MPWR-LTR-12-00101

Babcock & Wilcox mPower, Inc.  
Docket Number-PROJ0776  
Project Number-776

Subject: Submittal of Babcock and Wilcox mPower, Inc. (B&W mPower) Instrument Setpoint  
Methodology Topical Report R0003-08-002089-A, Revision 003

**Figure A.2: Relationships between analytical limit and calculated setpoints**

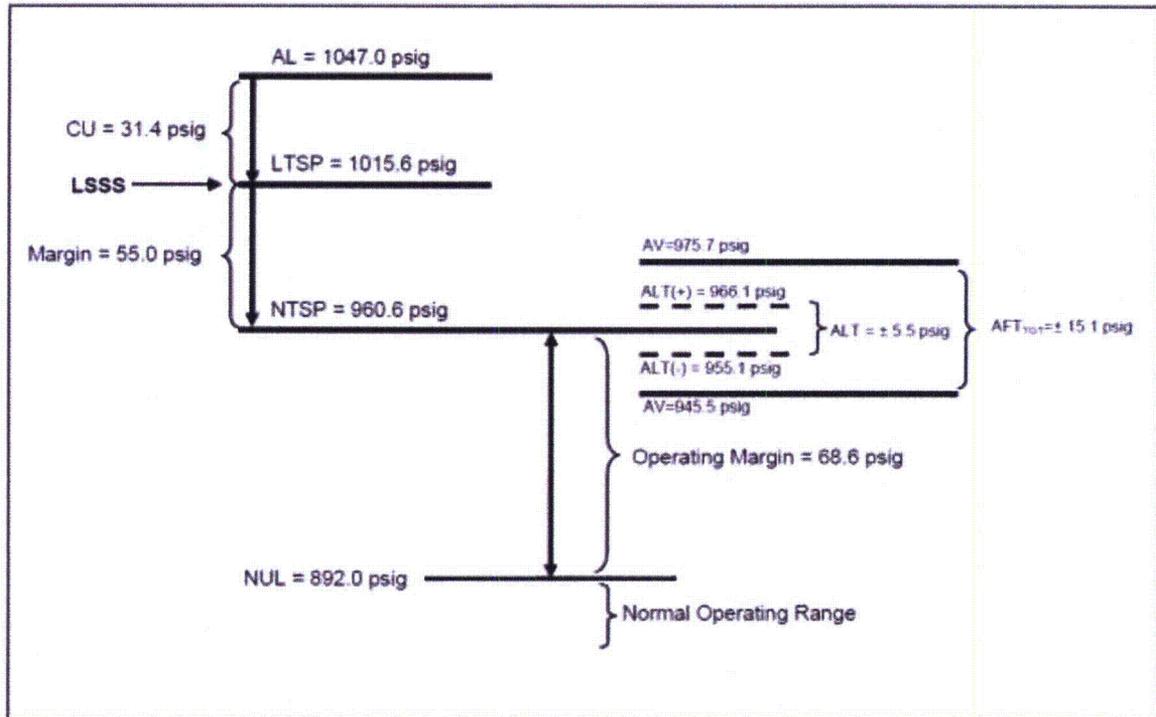
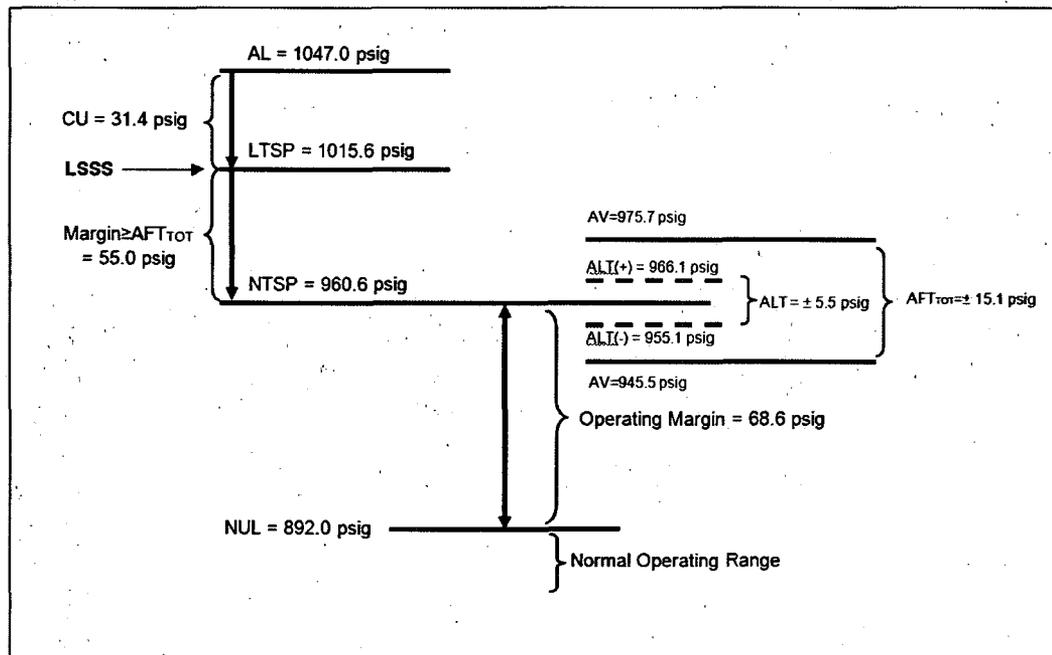
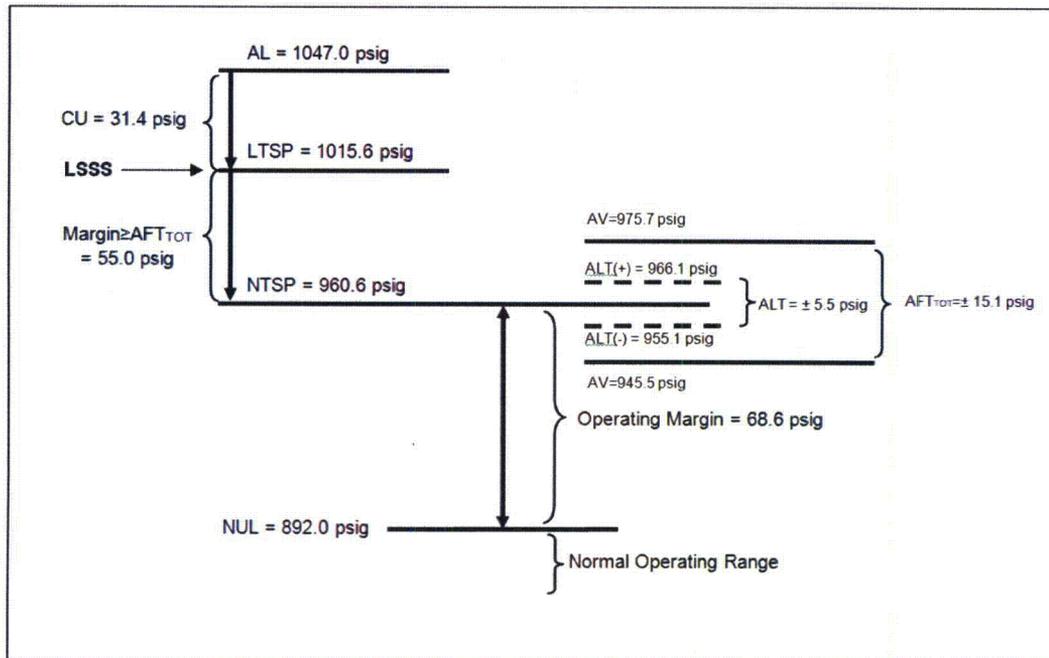
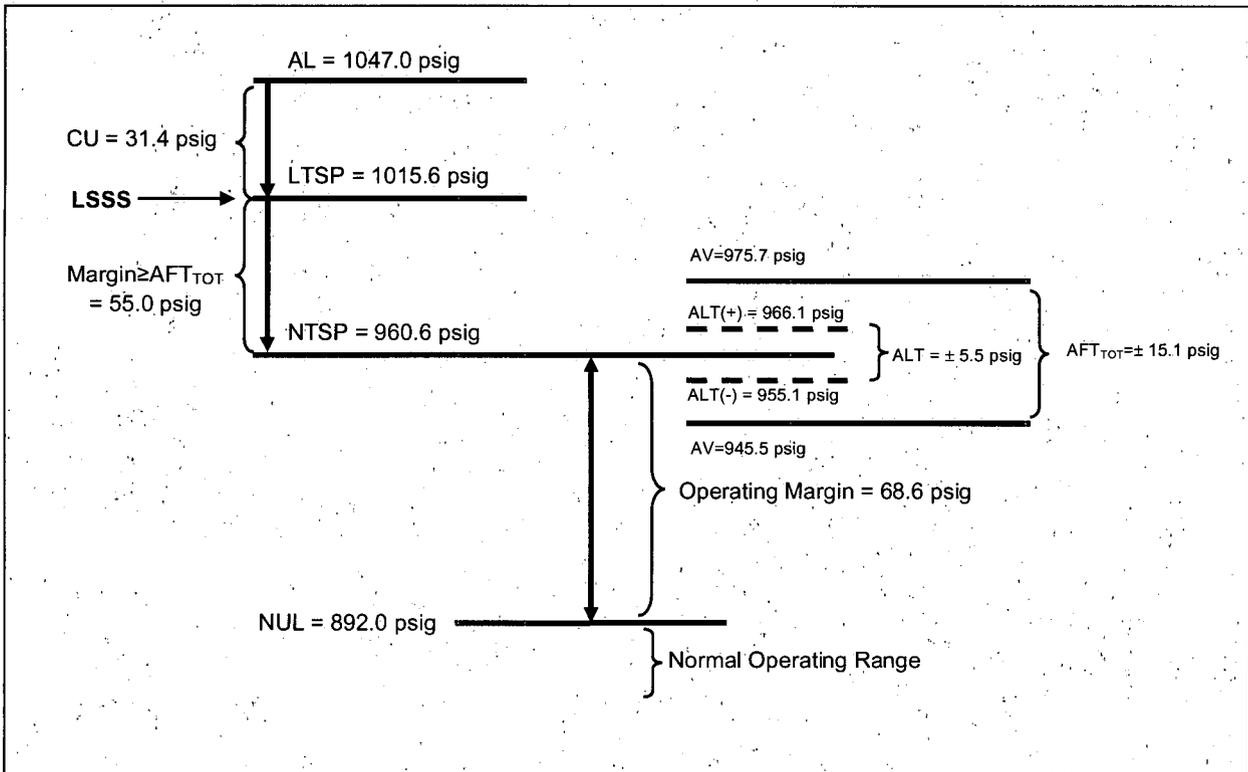
**Appendix A Figure A.2** - The staff requests the applicant to respond to the following:

- Is margin correctly shown as 5.5 psig?
- Using example problem and Notes 1& 2 from Figure 5.1, what would AV, Margin 2 and  $AFT^{TOT}$  be if Margin 1 is 5.5 psig (allowed by note 1) versus 55 psig?

**Appendix A Figure A.2 - The staff requests the applicant to respond to the following:**

- Is margin correctly shown as 5.5 psig?
- Using example problem and Notes 1 & 2 from Figure 5.1, what would AV, Margin 2 and  $AFT^{TOT}$  be if Margin 1 is 5.5 psig (allowed by note 1) versus 55 psig?

Appendix A Figure A.2 contains a typographical error where the margin was incorrectly shown as 5.5 psig. The proper value for the margin as determined in this example is 55.0% of the span which is 55.0 psig.

Based on the revision to Figure 5.1 and section 4.2.4 discussed in response to Question 07.01-C Appendix-9, the relationship between the allowable value, as-found and as-left tolerances is more clearly understood. Figure A.2 has been revised to more clearly illustrate the relationships in the example between the AFT and ALT as shown below:

Appendix A Figure A.2 contains a typographical error where the margin was incorrectly shown as 5.5 psig. The proper value for the margin as determined in this example is 5.0% of the span which is 55.0 psig.

Based on the revision to Figure 5.1 and section 4.2.4 discussed in response to Question 07.01-C Appendix-9, the relationship between the allowable value, as-found and as-left tolerances is more clearly understood. Figure A.2 has been revised to more clearly illustrate the relationships in the example between the AFT and ALT as shown below. Additionally, clarification has been added to indicate that the applied margin must be greater than or equal to the as-found tolerance to ensure that the AV never exceeds the LSSS.

**Figure 4.1: Setpoint Calculation Flow**

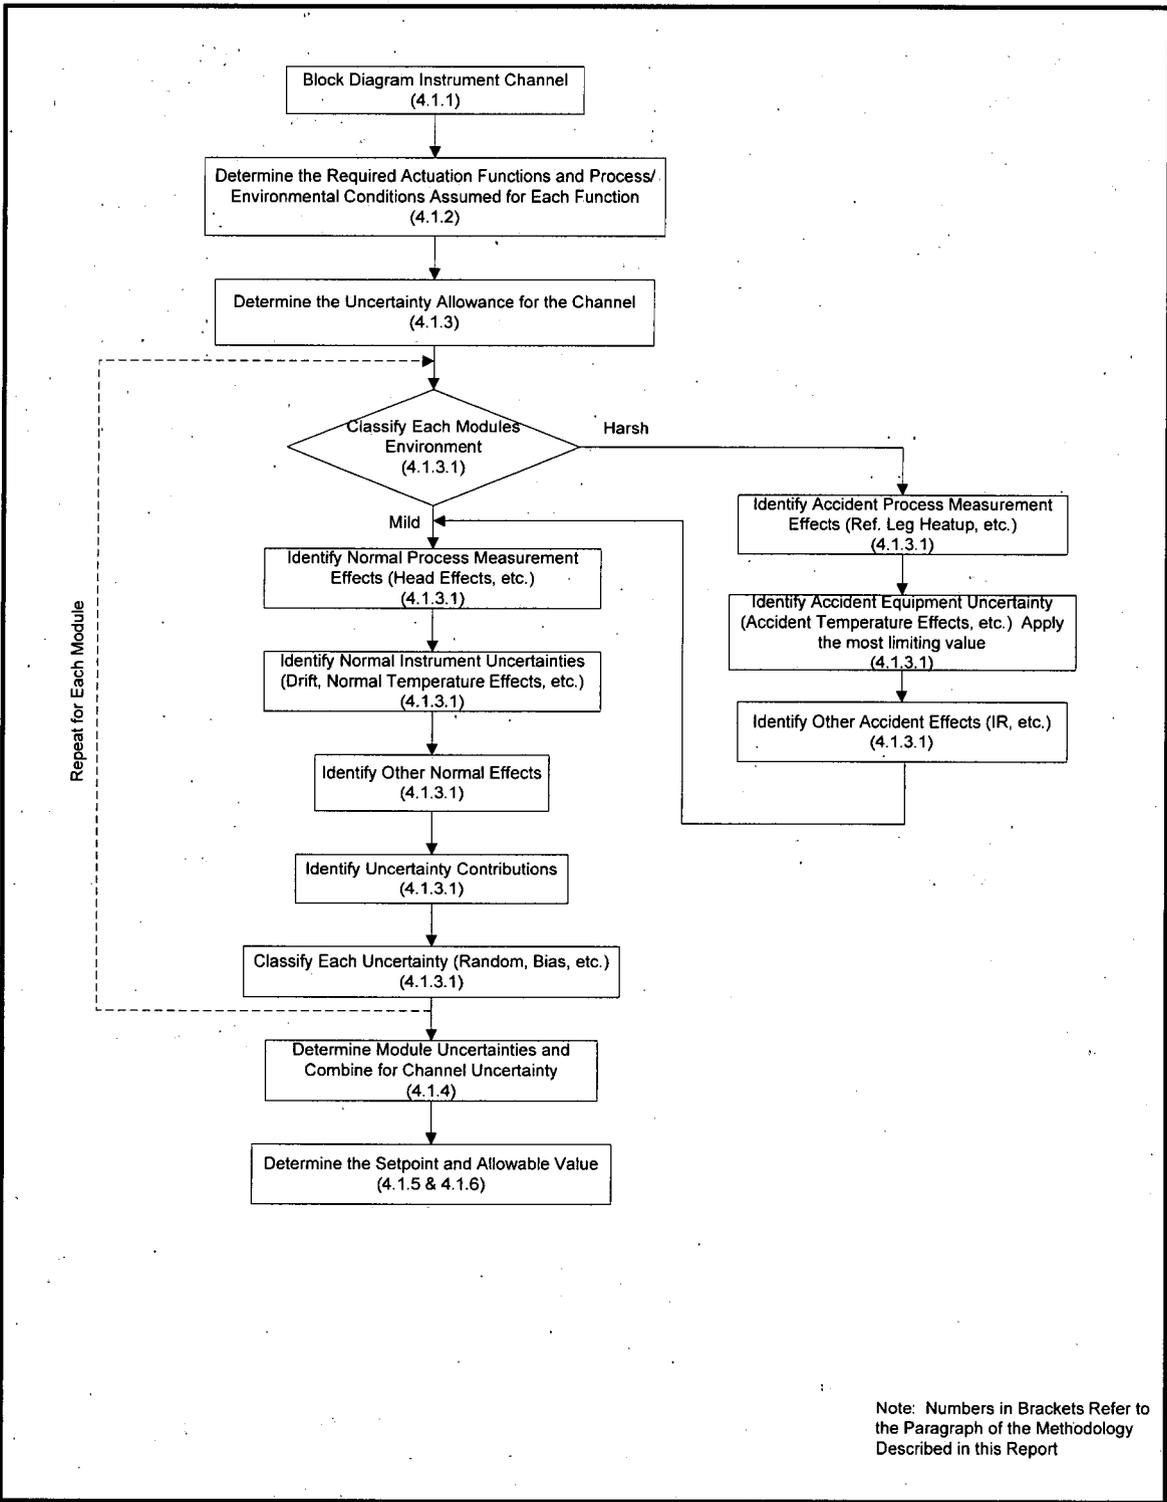
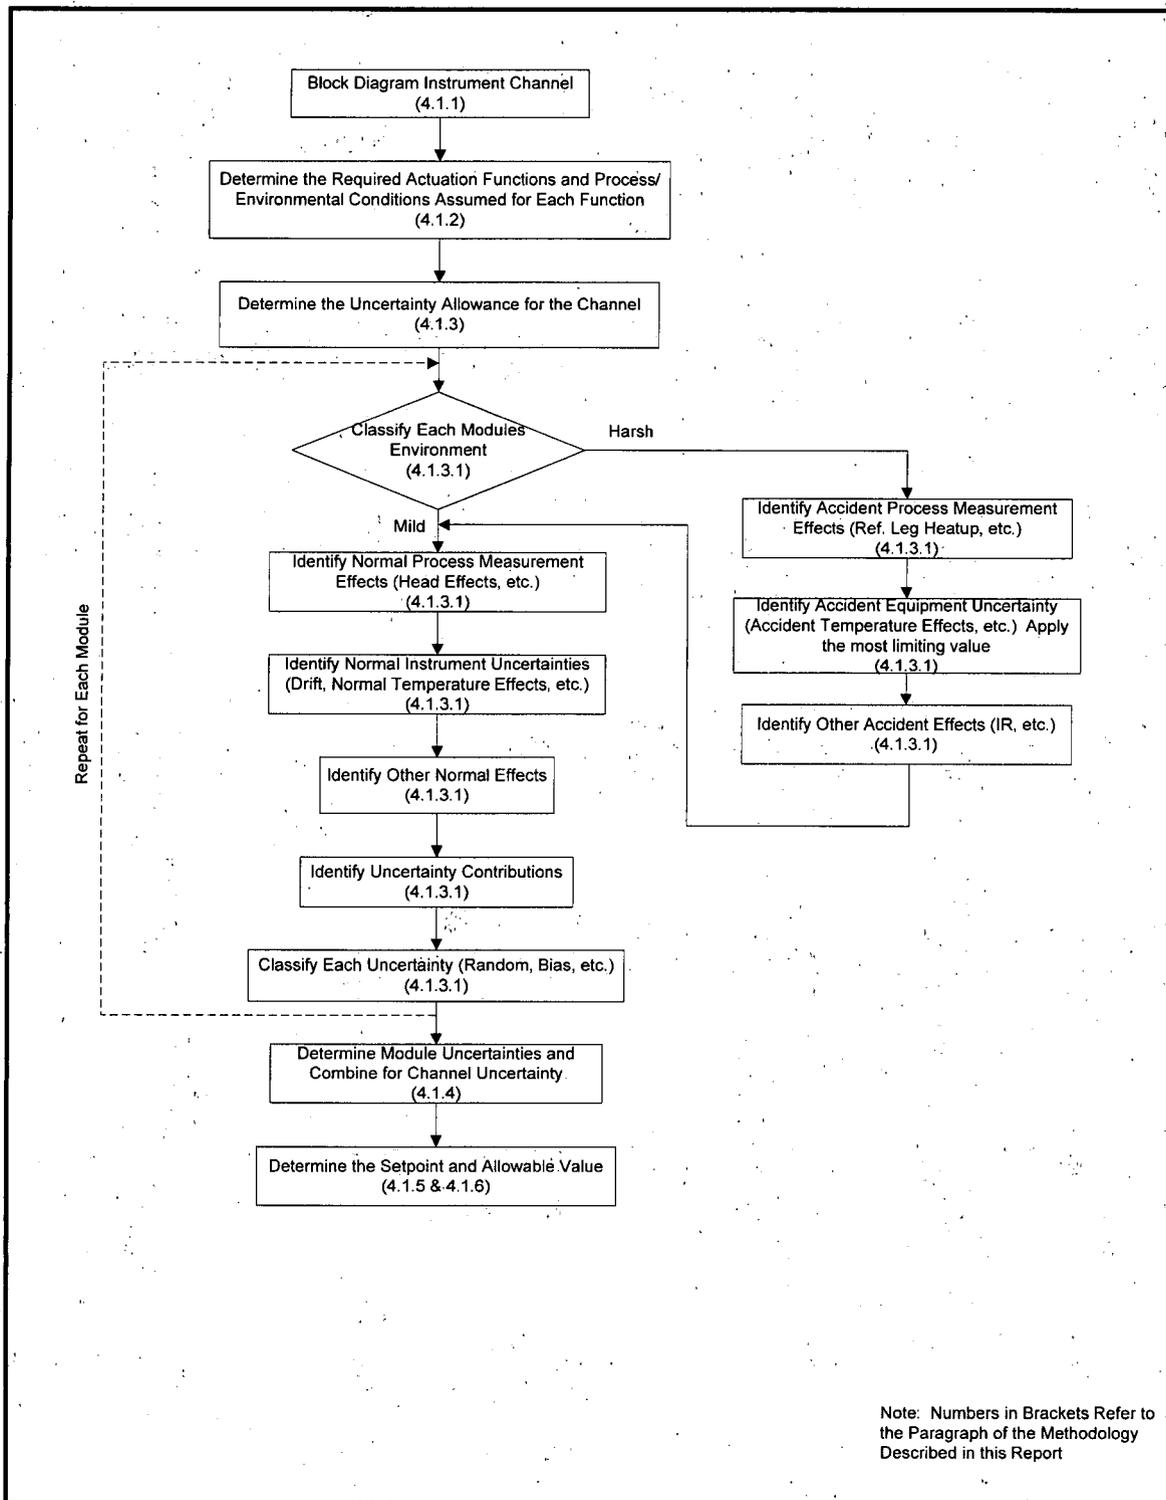
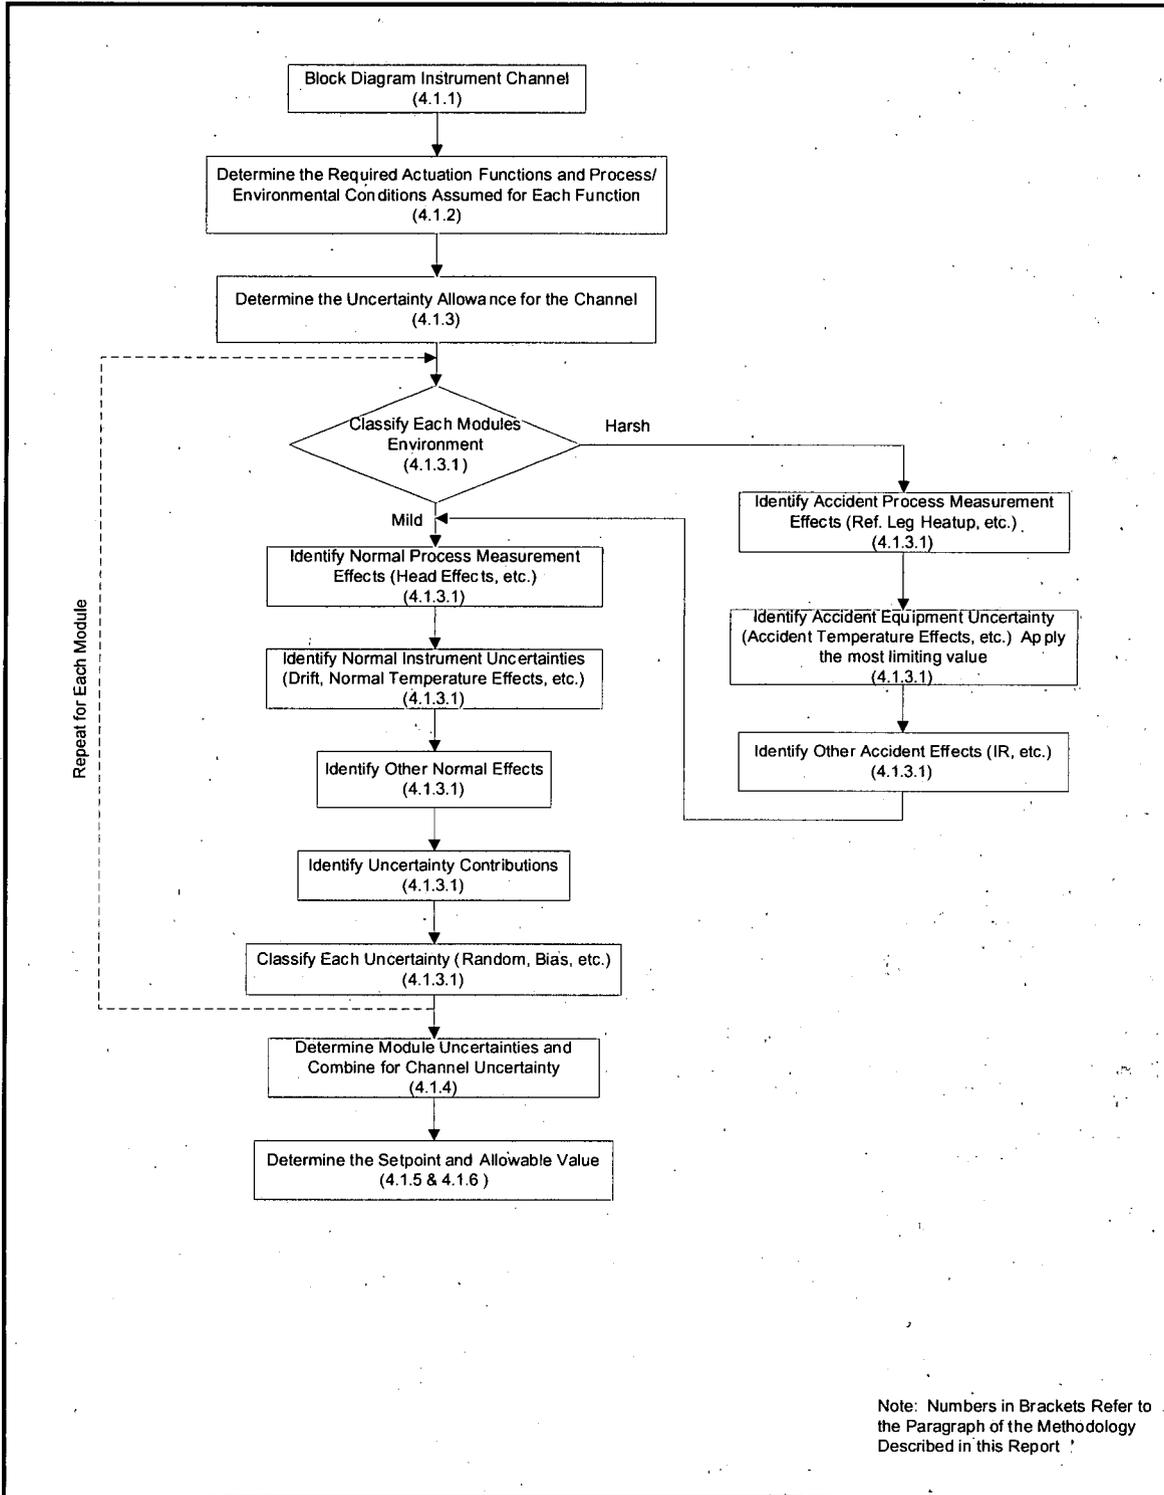
*Figure 4.1 - The setpoint steps at the bottom of the figure (below the step "Determine the Setpoint and Allowable Value"), deviate from ANSI/ISA 67.04.02 Figure 2. Explain how this meets the guidance in RG 1.105 Rev 3.*

**Figure 4.1** - The portion of the figure that shows the setpoint calculation for a harsh environment does not specify seismic effects as described in section 4.3.1.1 paragraph 2 and equation 4.2.1. Is seismic considered in figure 4.1 and if so how would this be applied to the setpoint calculation for normal, seismic, and other postulated accident conditions, as applicable?

Figure 4.1 of the B&W Instrument Setpoint Methodology is similar to Figure 2 in ANSI/ISA 67.04.02-2000, slightly amplified to provide more prescriptive guidance for obtaining the trip setpoint (NTSP) from the analytical limit (AL) based upon either an increasing or decreasing direction of the process variable. Figure 4.1 contains additional information not contained in Figure 2 of ANSI/ISA 67.04.02-2000, this additional information has been removed.

Figure 4.1 has been revised as shown on the following page.

The flow path presented in Figure 4.1 (page 9) is provided for illustrative purposes to demonstrate how, for instrument channels in harsh environments, the additional evaluation of uncertainties is required. It was not intended to list all uncertainty contributions for instrument channels subject to harsh conditions during normal or postulated design basis accident conditions in this figure.
